HISTORIC AND DESIGN REVIEW COMMISSION

February 21, 2018

HDRC CASE NO: 2018-022
COMMON NAME: 825 N ST MARYS
LEGAL DESCRIPTION: NCB 801 BLK 27 LOT E 48.33 FT OF 17
ZONING: D, RIO-3
CITY COUNCIL DIST.: 1
APPLICANT: Mitch McManus
OWNER: 825 N St Mary's, LLC
TYPE OF WORK: Construction of five, three story residential structures
APPLICATION RECEIVED: December 20, 2017
60-DAY REVIEW:
REQUEST:

The applicant is requesting a Certificate of Appropriateness to construct five, three story residential structures on the vacant located at 825 N St Mary's street.

RICHMOND TOWNHOMES
825 N. ST. MARY'S STREET
SITE PLAN

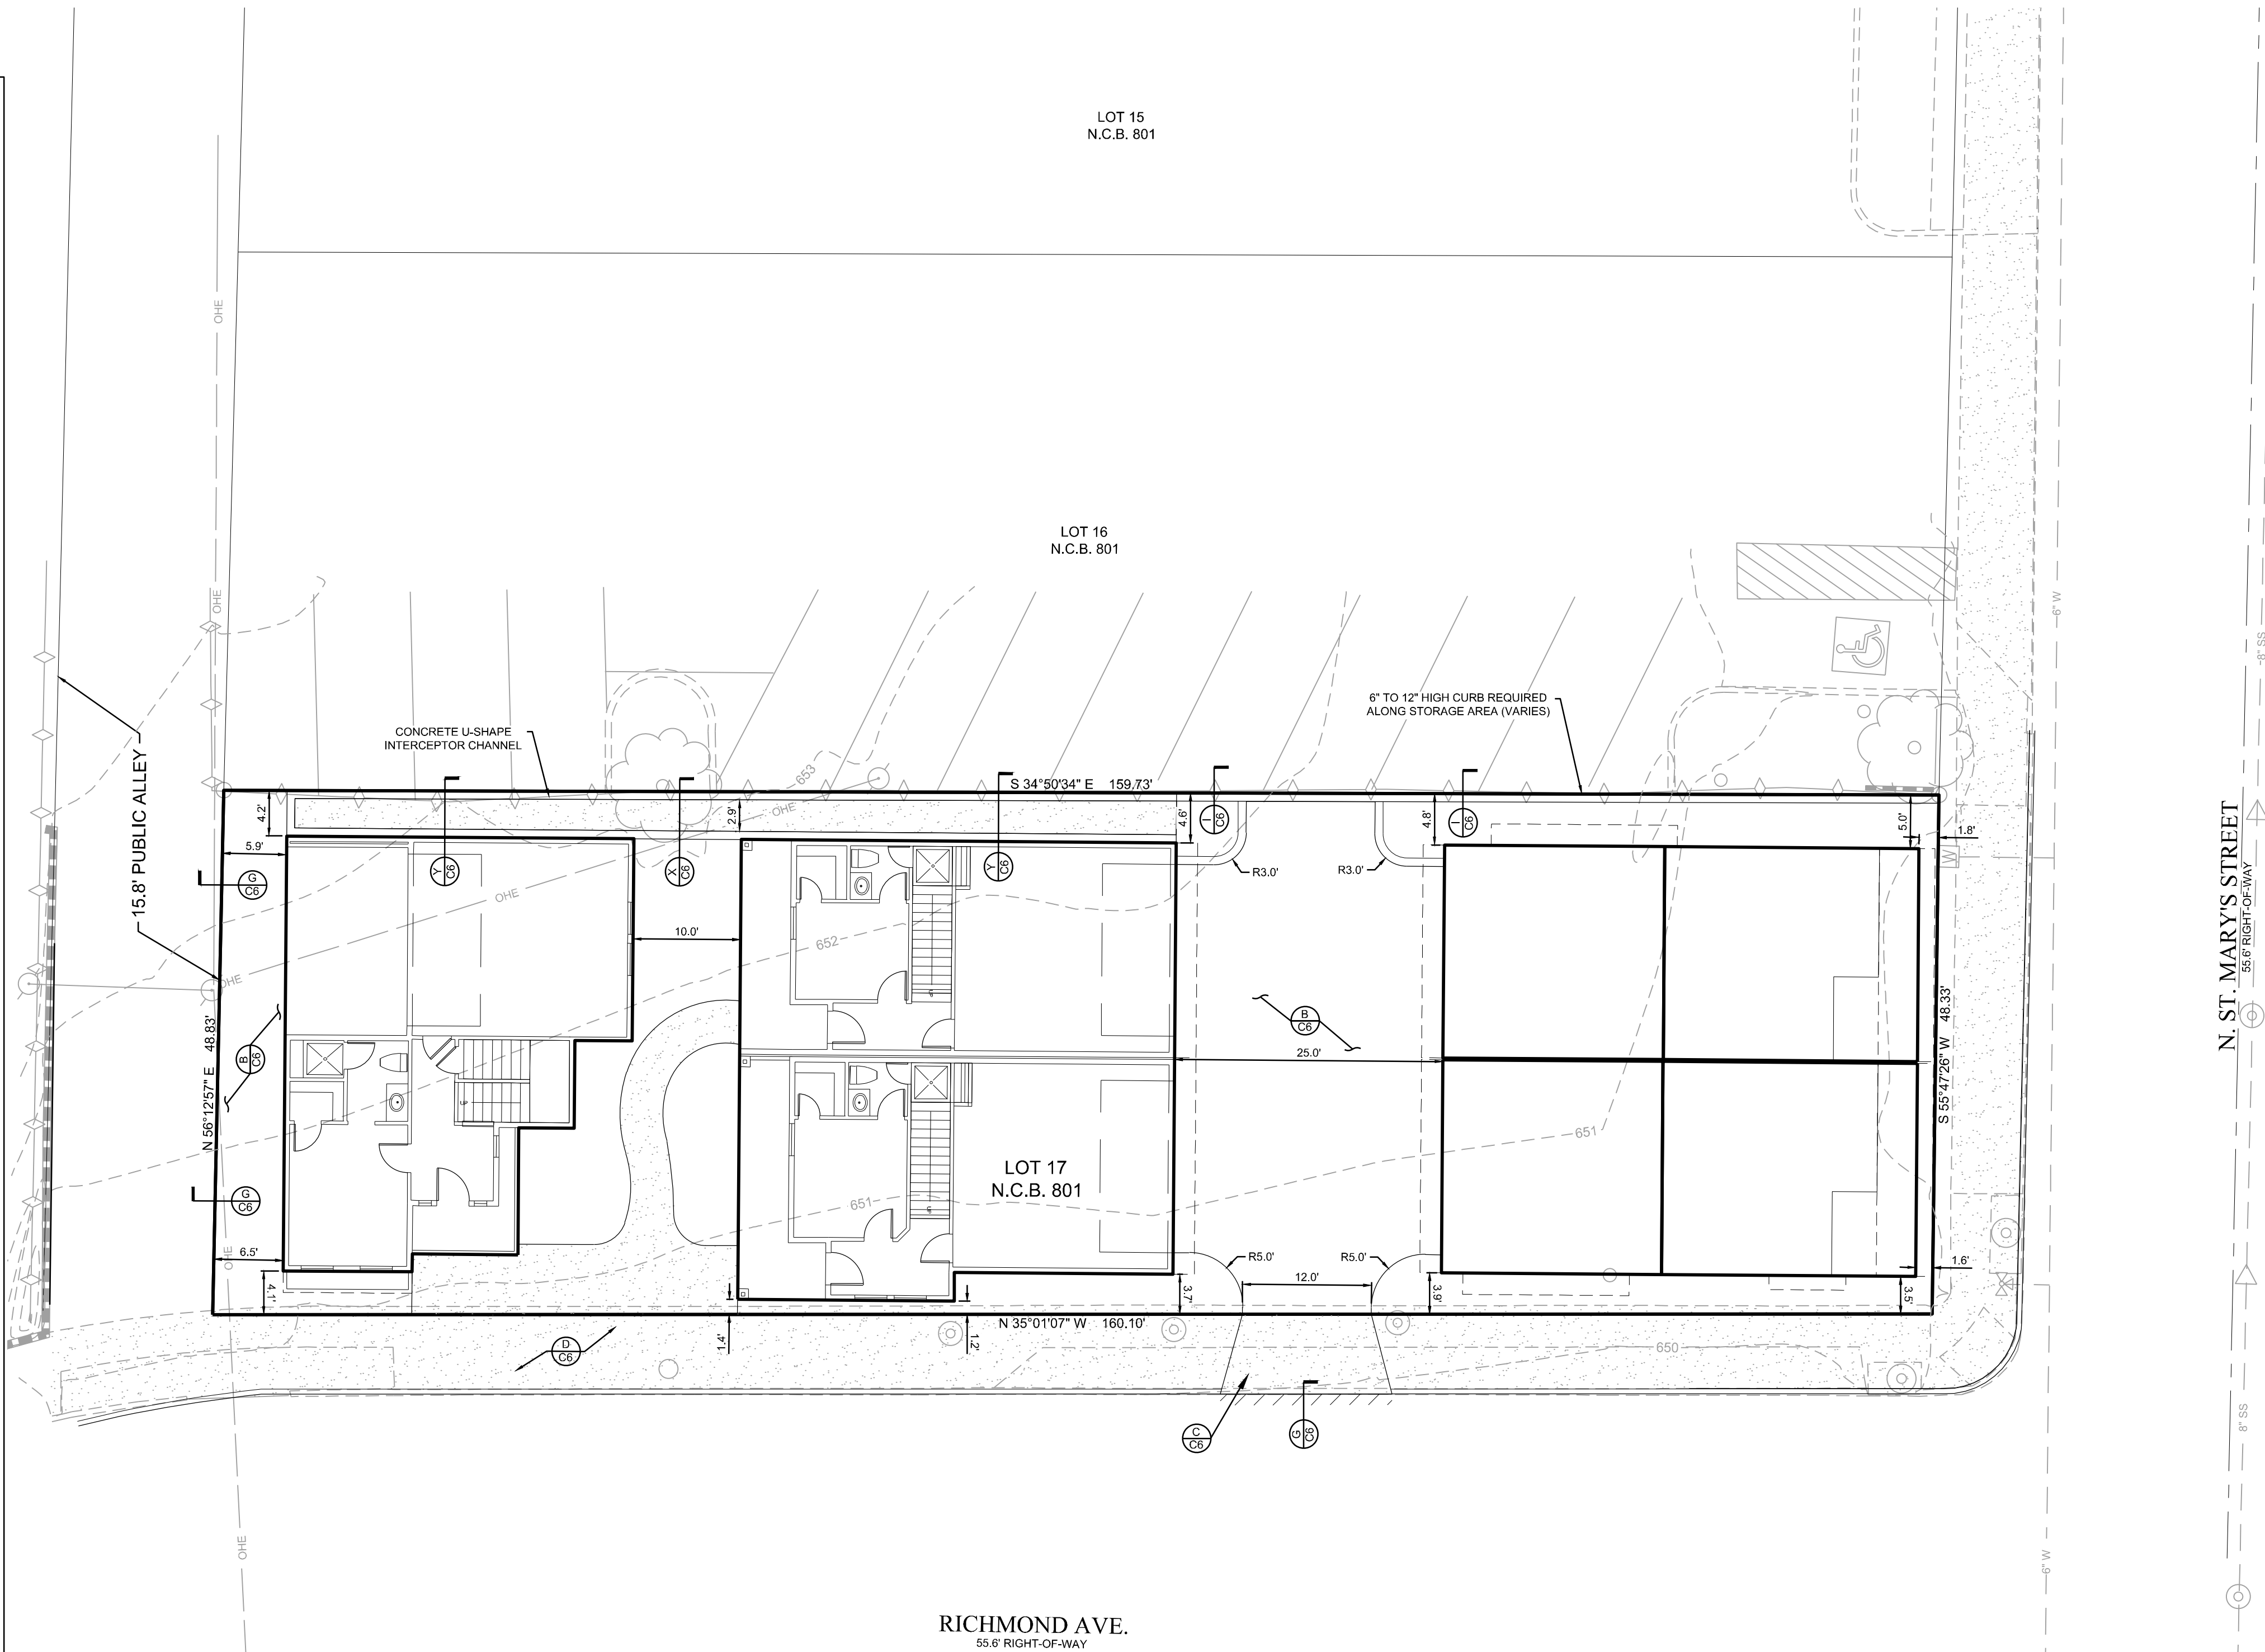
- h. **LANDSCAPING** – The applicant has provided a landscaping plan noting the location of various landscaping elements including shrubbery and fencing. Final landscaping materials are to be submitted to staff for review prior to approval.
